**CITY OF KELOWNA**  
**MEMORANDUM**

**APPLICATION NO.** OCP07-0009  
Z07-0026  
**OWNER:** 0763831 BC LTD.  
**AT:** 1315 Hwy.33 W  
1325 Hwy.33 W  
1345 Hwy.33 W  
145 Taylor Road  
155 Taylor Road  
165 Taylor Road  
**APPLICANT:** BOB GUY

**PURPOSE:** TO AMEND THE EXISTING OFFICIAL COMMUNITY PLAN  
FUTURE LAND USE DESIGNATION OF MULTIPLE UNIT  
RESIDENTIAL-LOW DENSITY TO MULTIPLE UNIT  
RESIDENTIAL-MEDIUM DENSITY;

TO CONSTRUCT A 49 UNIT, 3 STOREY APARTMENT  
HOUSING DEVELOPMENT ON THE SUBJECT PROPERTIES

WEST ELEVATION  
FACING TAYLOR RD

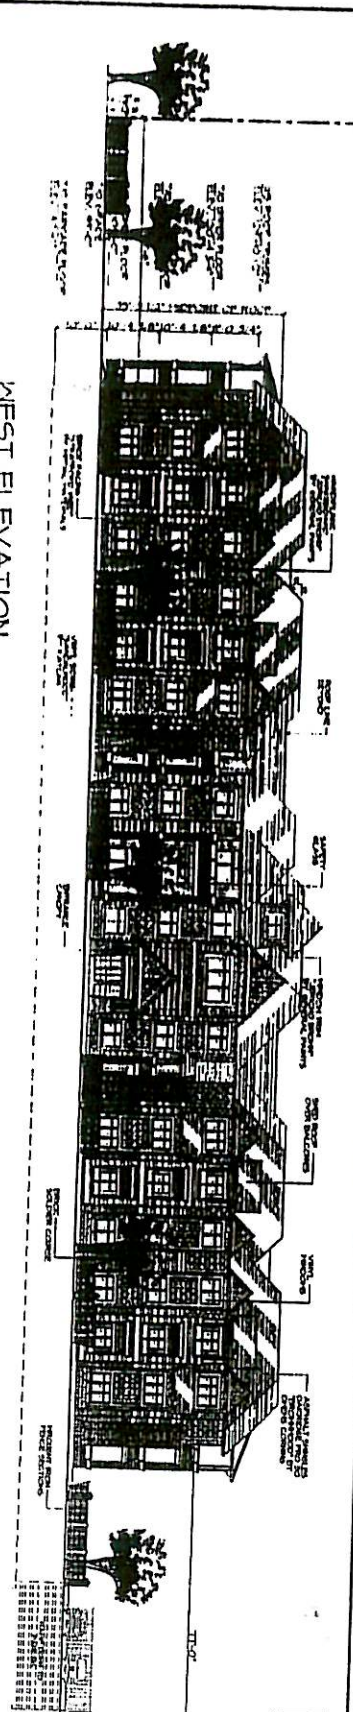
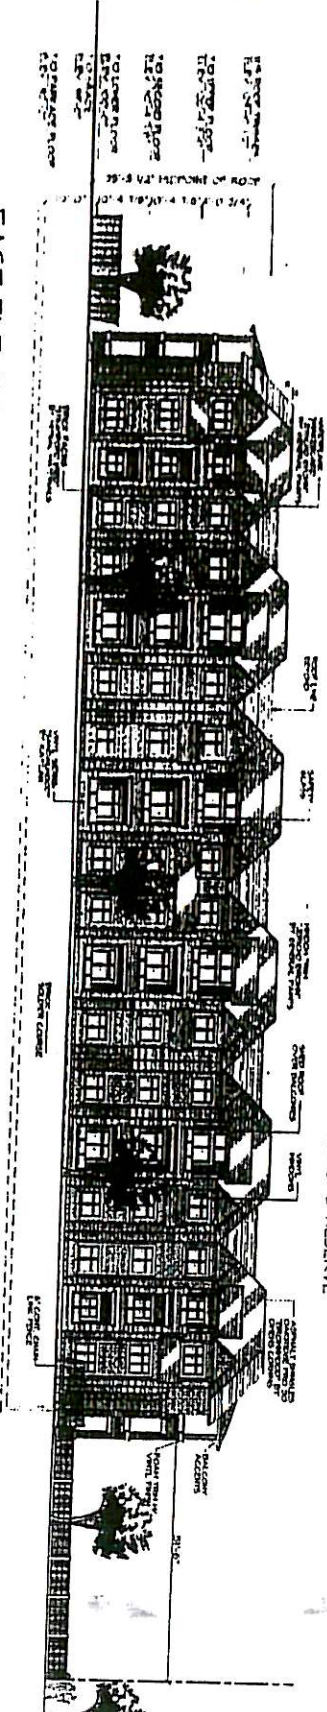
- First storey units do not provide ground-level access
- The principle front entranceway is not clearly identifiable and is out of scale with the development.
- Porches are not provided as there is no ground level access to units at grade.

- The proposed developments is not sensitive to and compatible with the massing and rhythm of the established streetscape.
- Sub-roofs, dormers, balconies, and bay windows are provided.
- Variation between architectural bays within each façade is provided but repetitious.

- End walls visible from a public street or residential lot should be finished to provide an attractive appearance. Blank or solid walls (without glazing) should not be longer than 5 m. Walls longer than 5 m should incorporate wall detailing that will provide visual interest.
